**Economic Commission for Europe****Inland Transport Committee****World Forum for Harmonization of Vehicle Regulations****Working Party on General Safety Provisions****127th session**

**UN Regulation No. 125 (Forward field of vision of drivers)****Proposal for the 03 series of Amendments to UN Regulation  
No. 125 (Forward field of vision of drivers)****Submitted by the Informal Working Group on Field of Vision  
Assistant \***

## "Annex 2

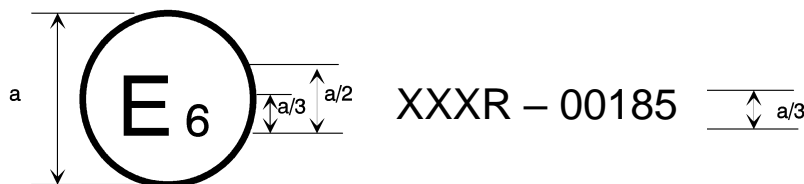
Annex 2, amend to read:

The above approval mark affixed to a vehicle shows that the vehicle type concerned has been approved in Belgium (E 6) with regard to the driver's forward field of vision pursuant to UN Regulation No. 125. The first two digits of the approval number indicate that the approval was granted in accordance with the requirements of UN Regulation No. 125 as amended by the 03 series of amendments."
